**SITE PLAN/ARCHITECTURAL REVIEW
CASE NO. 07-SPR-010**

**FOR THE PROPERTY LOCATED AT
6021 COLODNY DRIVE, AGOURA HILLS**

CITY OF AGOURA HILLS - GEOTECHNICAL REVIEW SHEET

Planning Case #: 07-SPR-010 (Araujo, Ruben)

GRADING AND DRAINAGE PLAN
 6021 COLODNY DRIVE
 AGOURA HILLS, CA 91301
 PROJECT NO. 07-SPR-010, APN 20555-028-036
 SHEET 2 OF 4

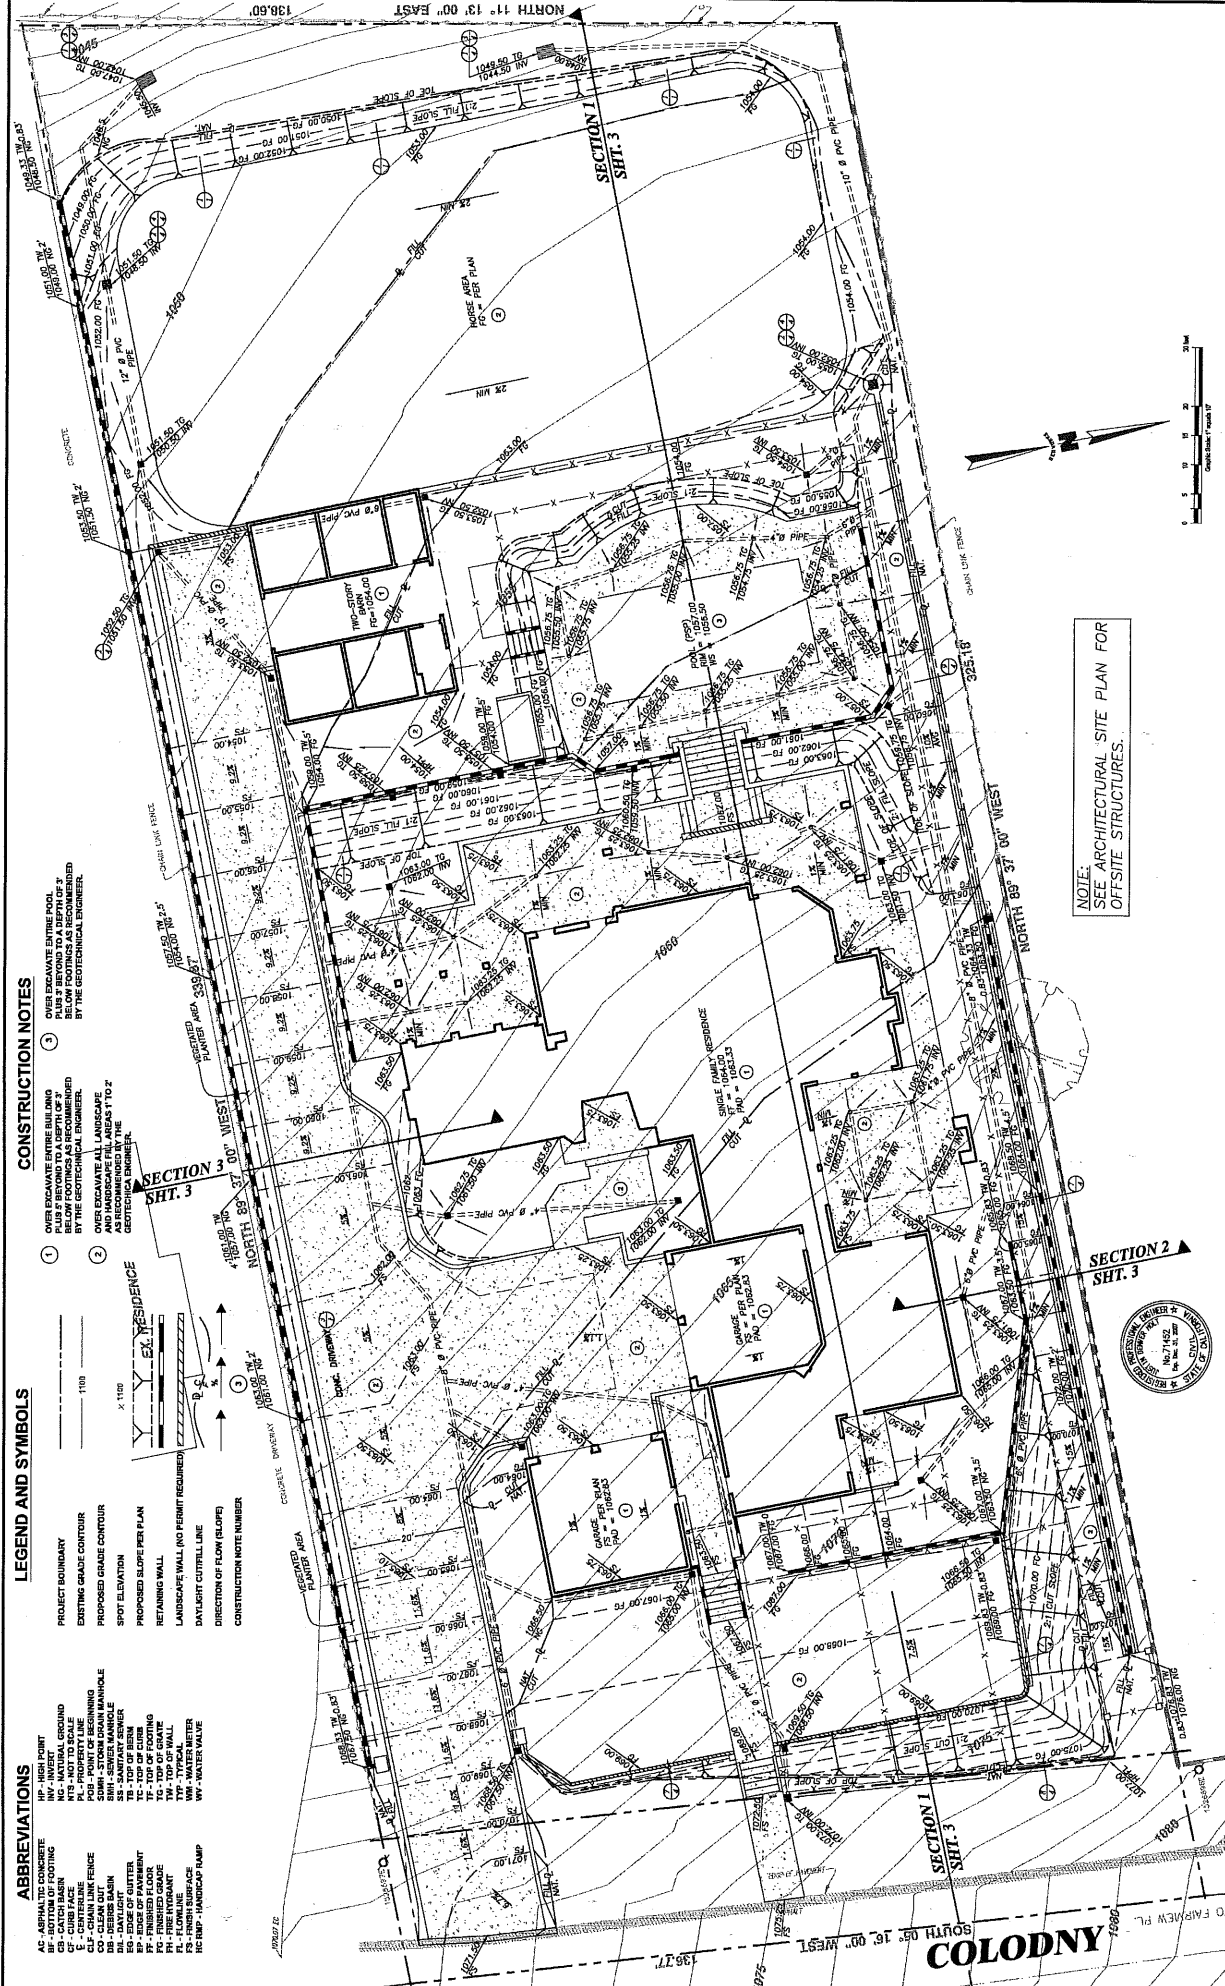
2. The grading plan should include the limits and depths of overexcavation of the building pad and flatwork areas as recommended by the Consultant.
3. The following note must appear on the grading and foundation plans: *"Tests shall be performed prior to pouring footings and slabs to determine the expansion index of the supporting soils, and foundation and slab plans should be reviewed by the Geotechnical Consultant and revised, if necessary, accordingly."*

6. Foundation plans and foundation details shall clearly depict the embedment material and minimum depth of embedment for the foundations.
7. Drainage plans depicting all surface and subsurface non-erosive drainage devices, flow lines, and catch basins shall be included on the building plans.
